Subject: RE-CIRCULATION - OPA/ZBA (1001 King Street East)

Date:	January 6, 2023
То:	Katie Anderl, Senior Planner
From:	Deeksha Choudhry, Heritage Planner
cc:	
Subject:	OPA22/001/K/KA ZAB22/002/K/KA 1001-1051 King Street East & 530-564 Charles Street East Heritage Planning Comments

Re: Proposed Official Plan Amendment OPA 22/01 and Zoning By-law Amendment ZBA 22/01 – 3rd submission 1001-1051 King Street East and 534-564 Charles Street East MHBC Planning (C/O Pierre Chauvin) on behalf of King-Charles Properties (Kitchener) (C/O Stephen Litt) CITY OF KITCHENER

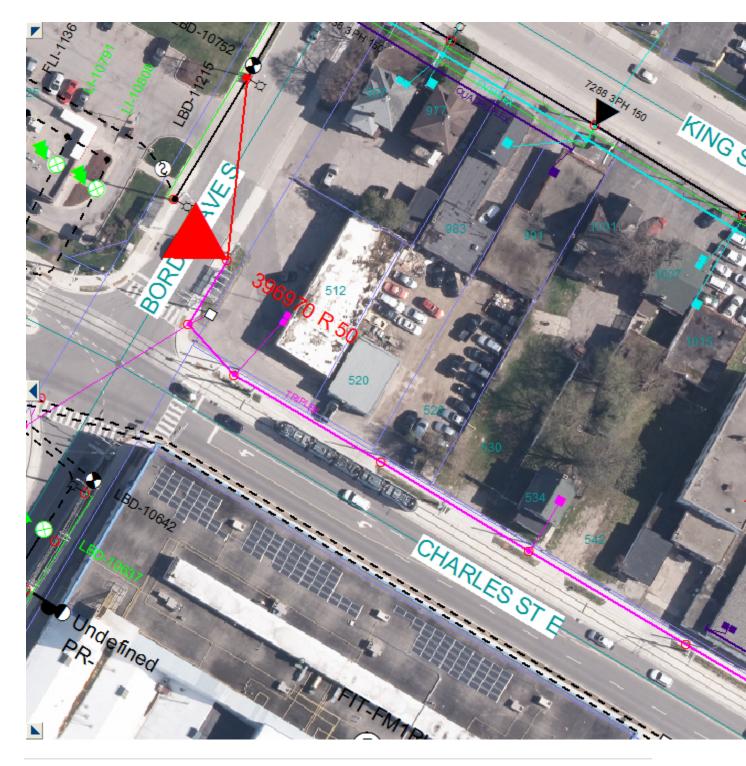
The developer shall make satisfactory arrangements with Kitchener Wilmot Hydro Inc. for servicing:

- 1. Kitchener-Wilmot Hydro has existing overhead pole lines on both King St side and Charles St side, close to the property line.
- 2. Any proposed above grade building façade must have a minimum clearance of 5.5 meters from the center of hydro pole line.
- 3. Any adjustment to Kitchener Wilmot Hydro Inc. existing facilities will be at the developers cost.
- 4. To service the site, on-site distribution transformer (either pad-mounted or room type) may be required, as per Kitchener-Wilmot Hydro standards. The transformer room shall be at grade.
